Development Review Team Comments

Project Number: PRC2021-00005

Project Name: Sherrelwood Village FDP Amendment & Filing 2 Preliminary

PART OF THE NORTHEAST QUARTER SECTION 33 AND THE SOUTHEAST QUARTER OF SECTION 28, TOWNSHIP 2 SOUTH, RANGE 68 WEST OF THE SIXTH PRINCIPAL MERIDIAN, COUNTY OF ADAMS, STATE OF COLORADO PRELIMINARY PLAT SHEET 5

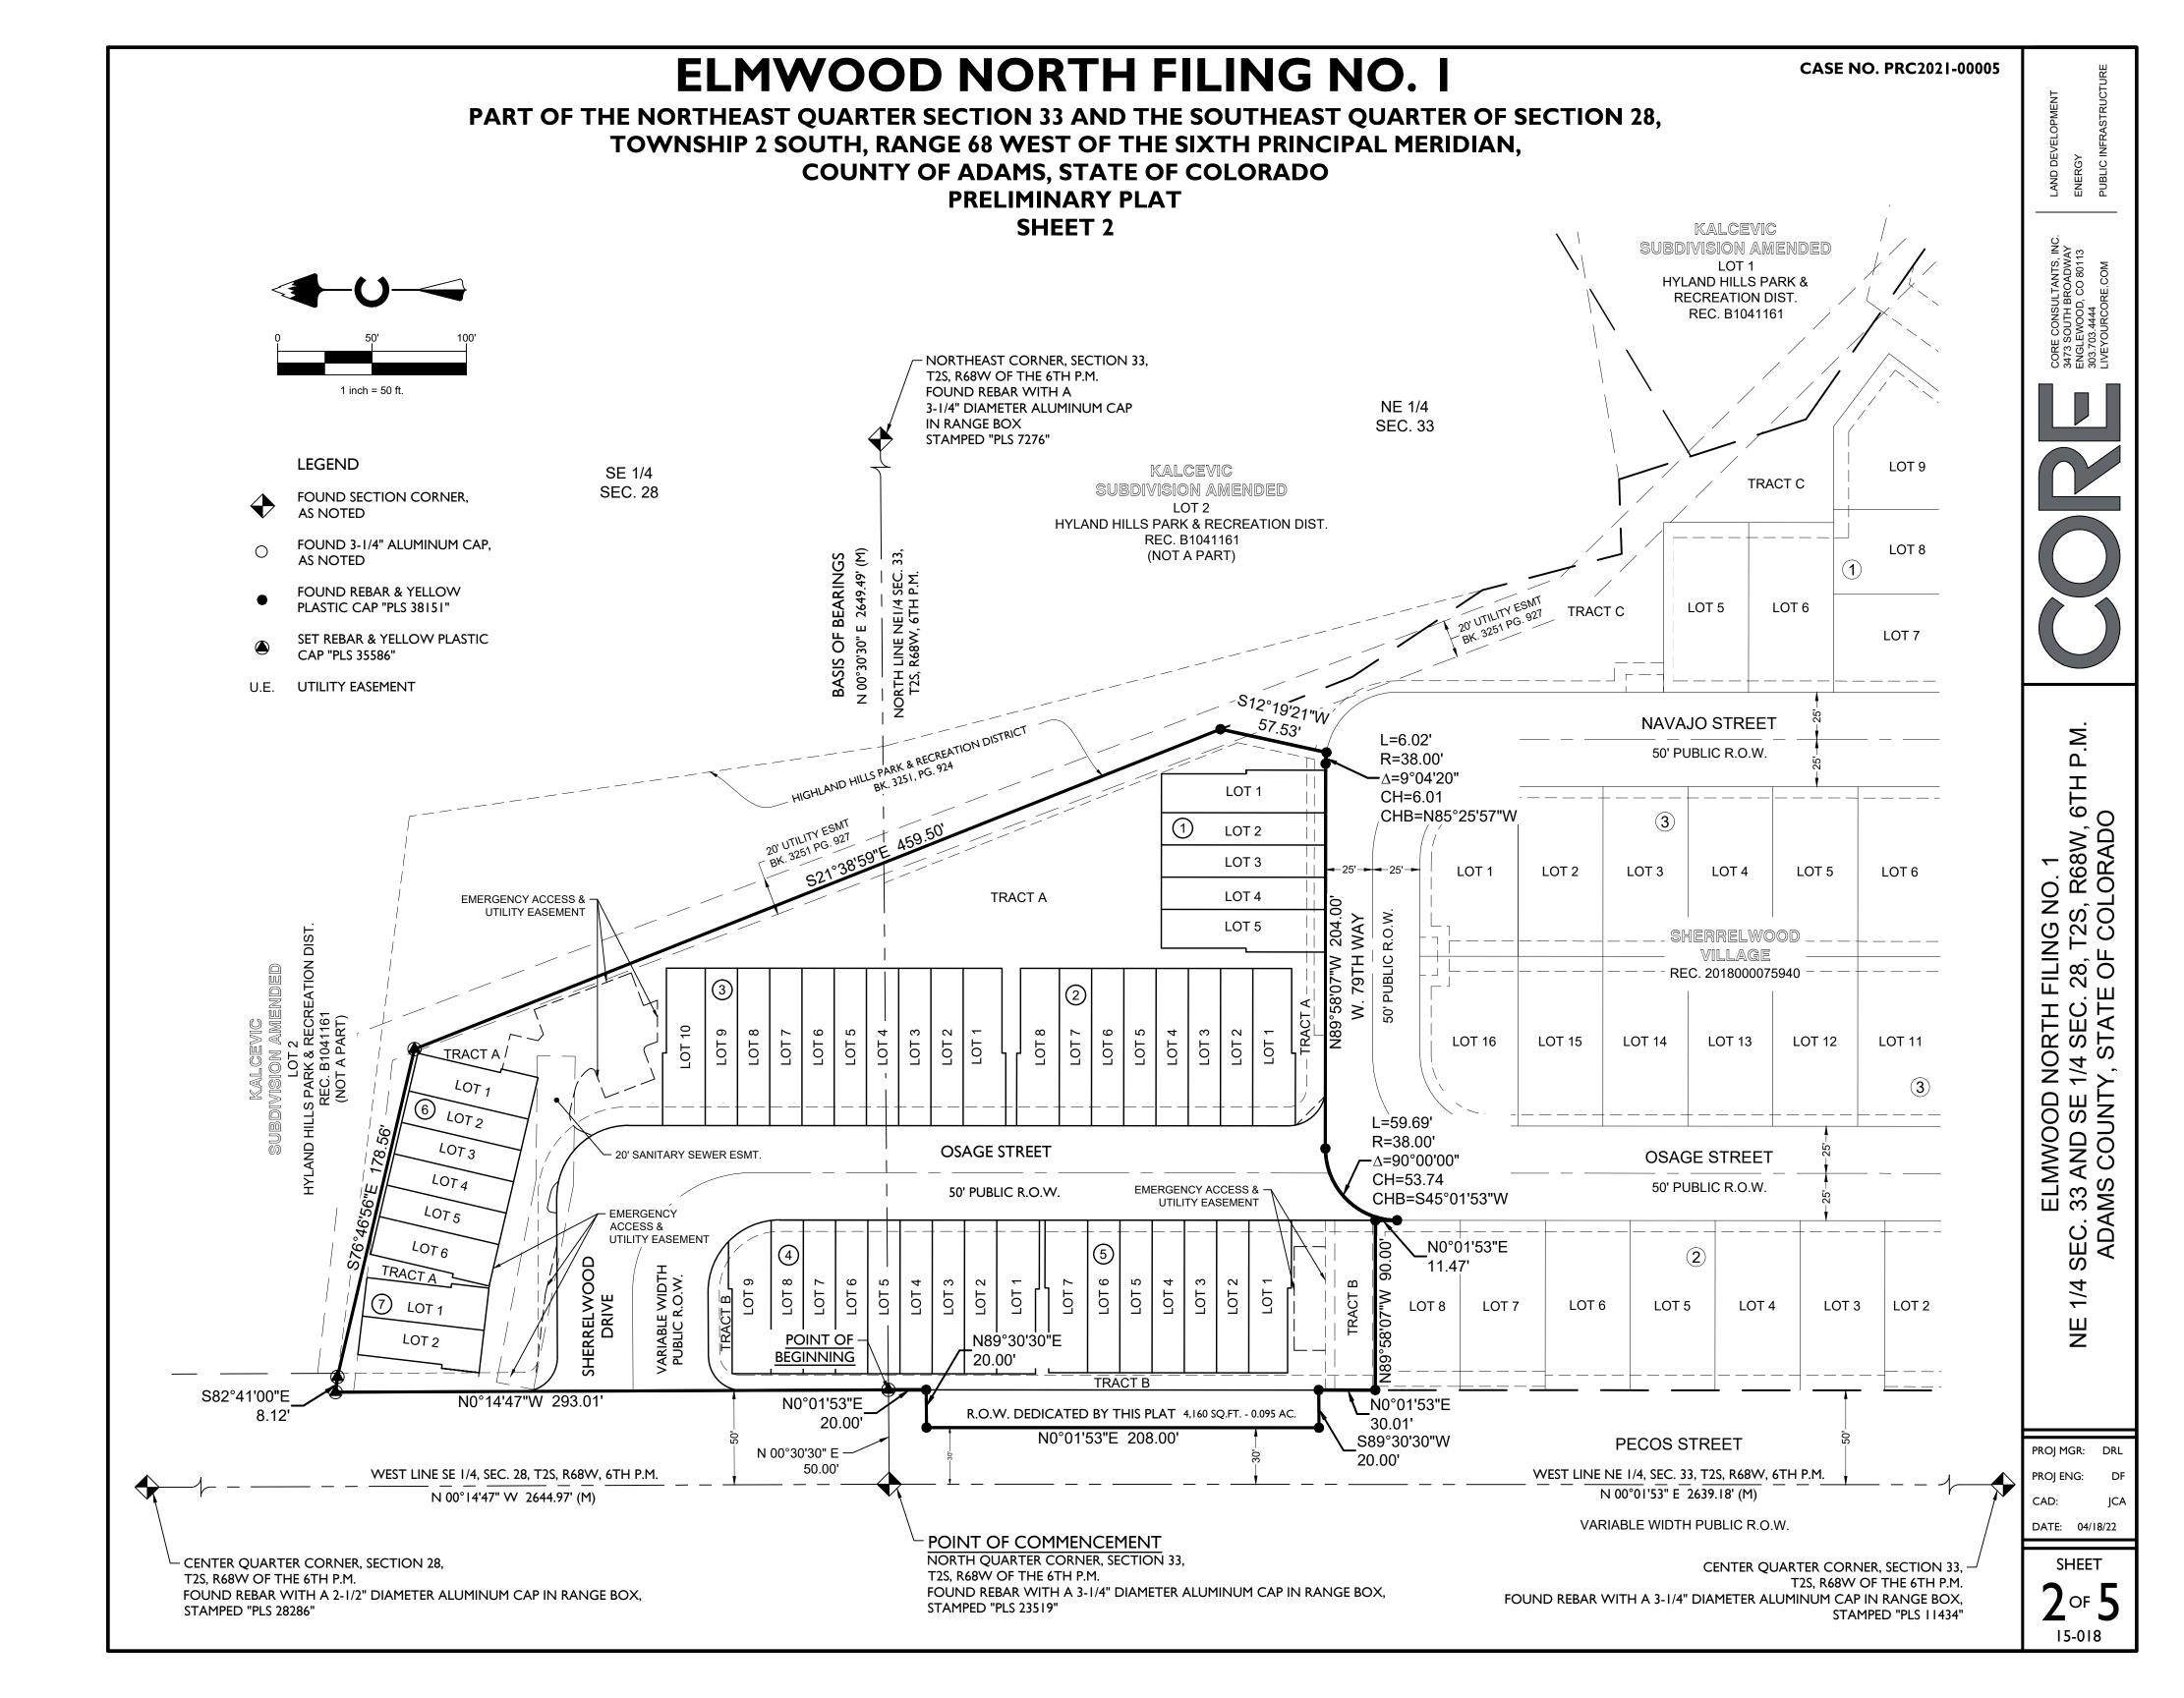
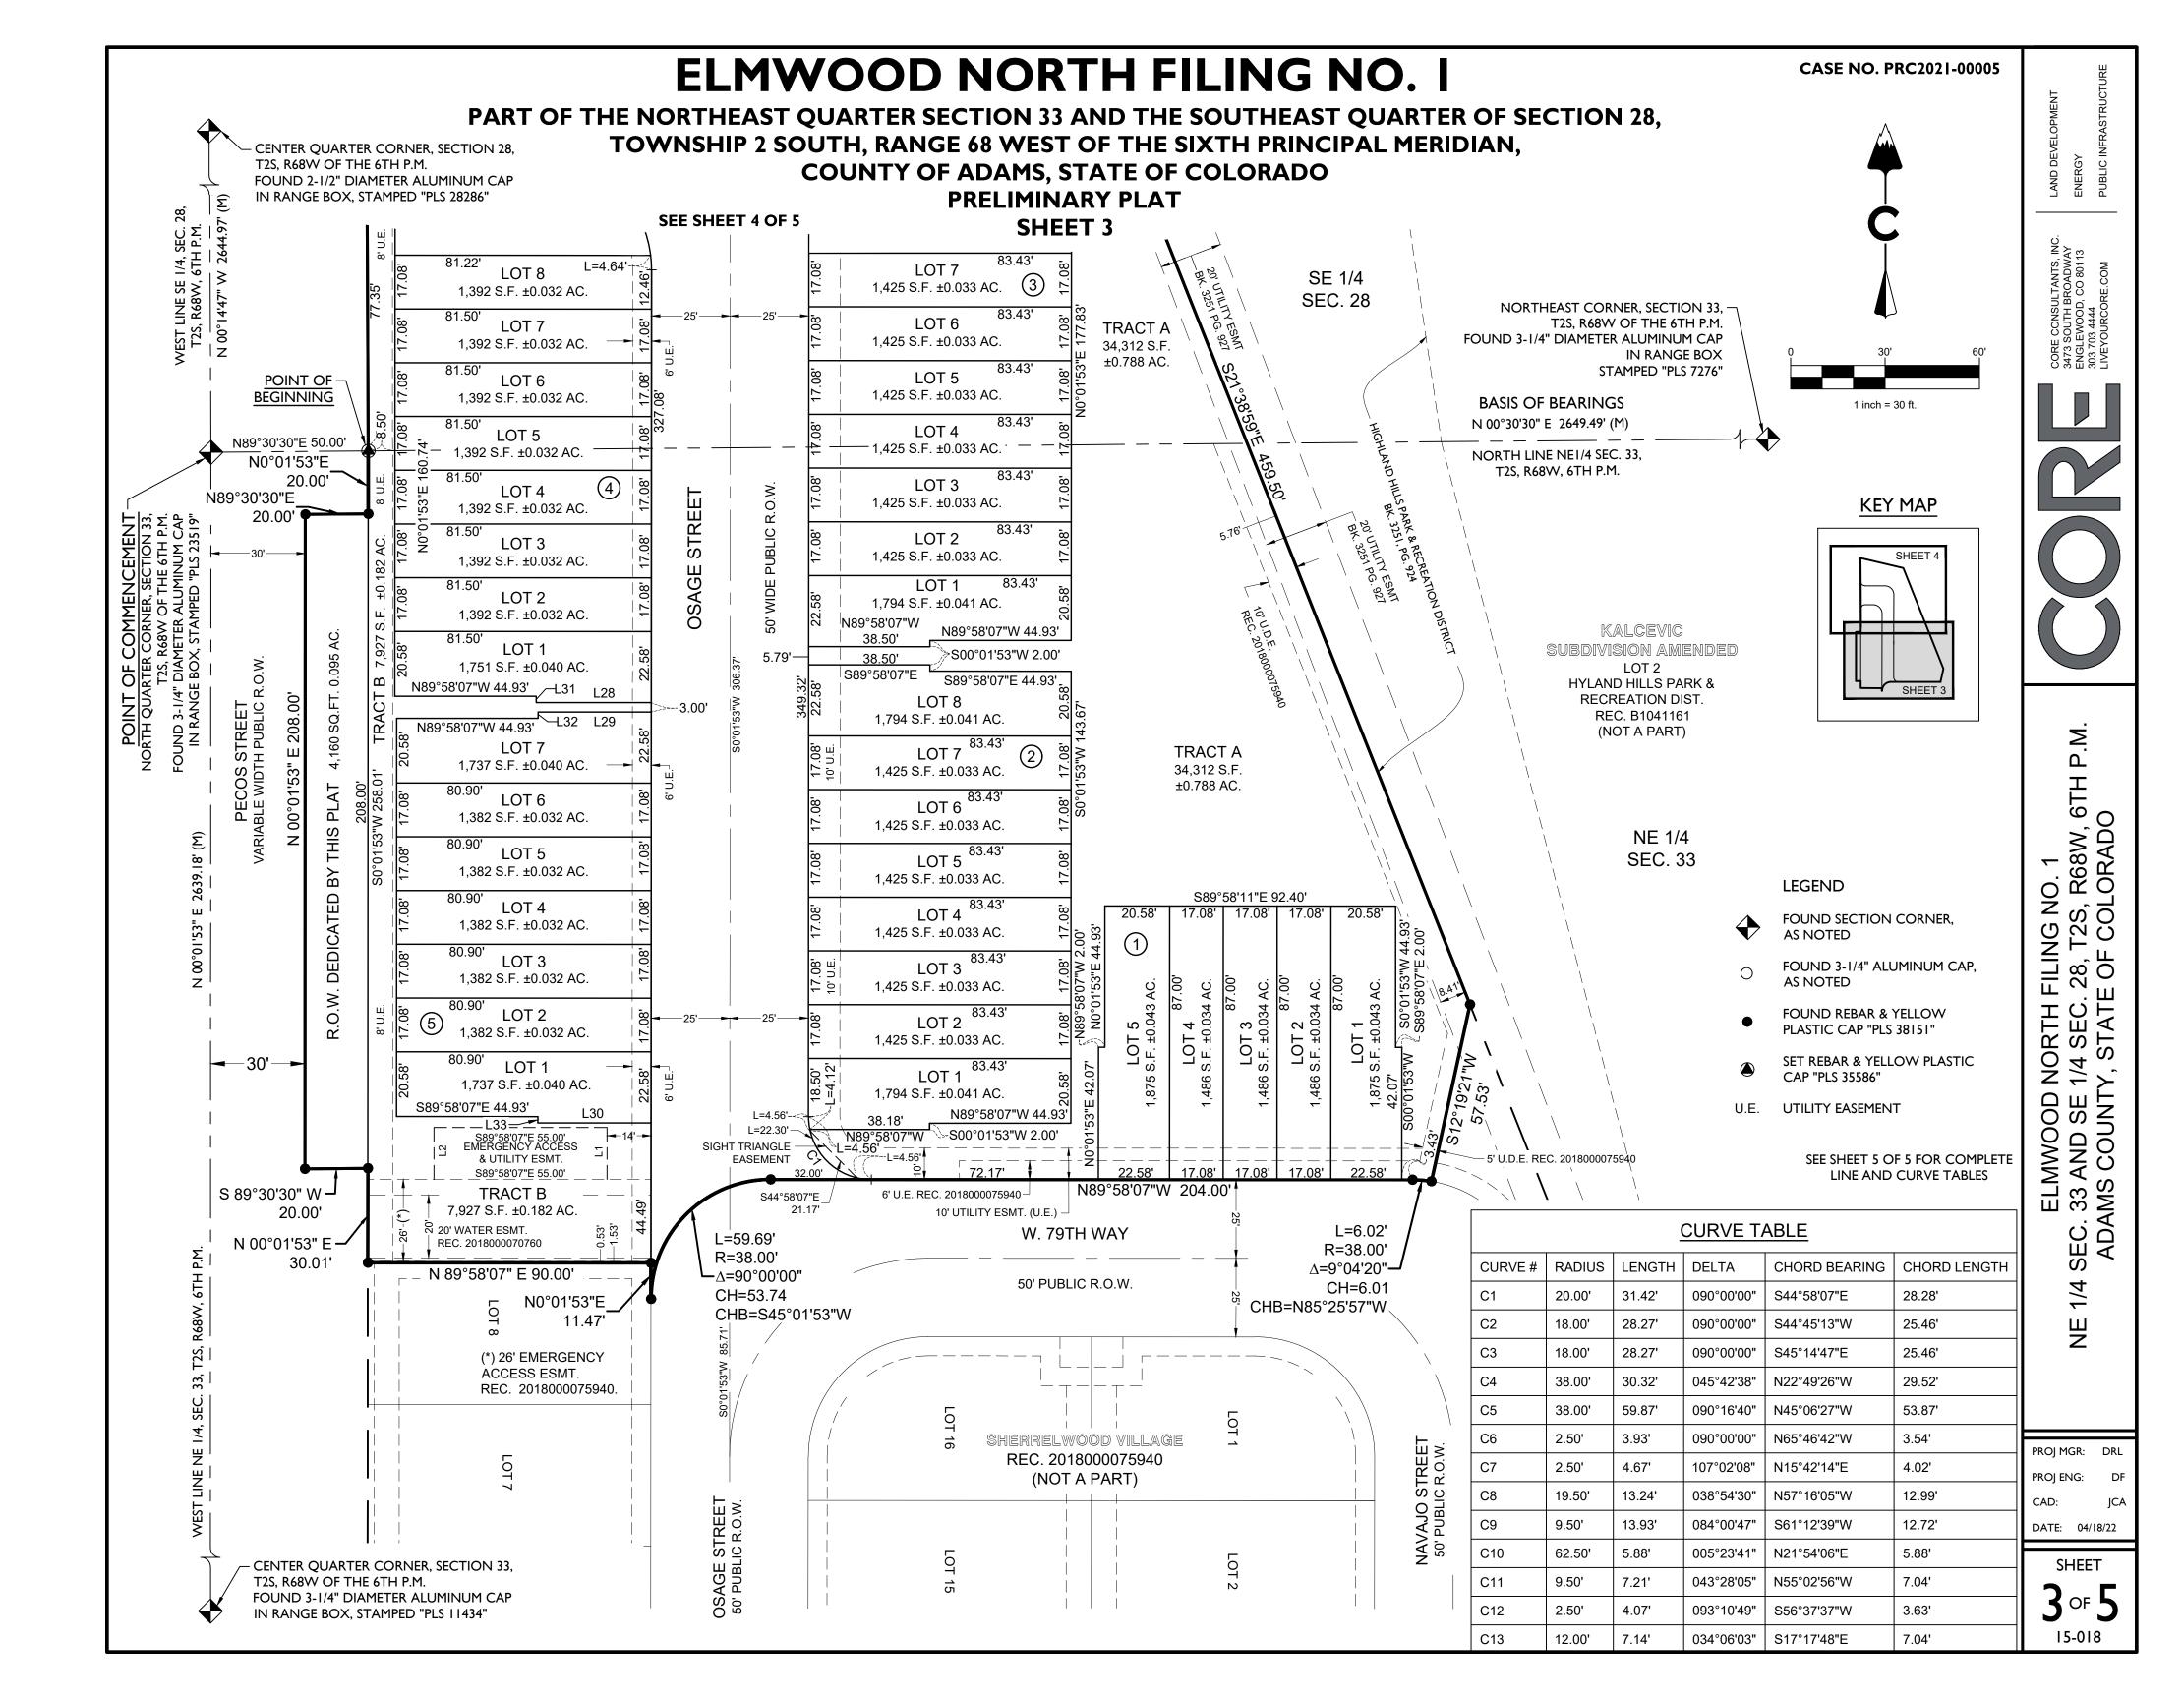
ROW3: If you want to dedicate anything to the City of Thornton, they need to have an acceptance block and affirmation on the plat. Otherwise remove this statement on Sheet 5. If the easement is off of Pecos on Sherrelwood Drive, then the note should read to be dedicated by separate instrument, or if they are a signatory, can dedicate by this plat. Adams County cannot accept dedications for other municipalities without the expressed written acceptance. RESPONSE: Thornton easement note removed from sheet 5
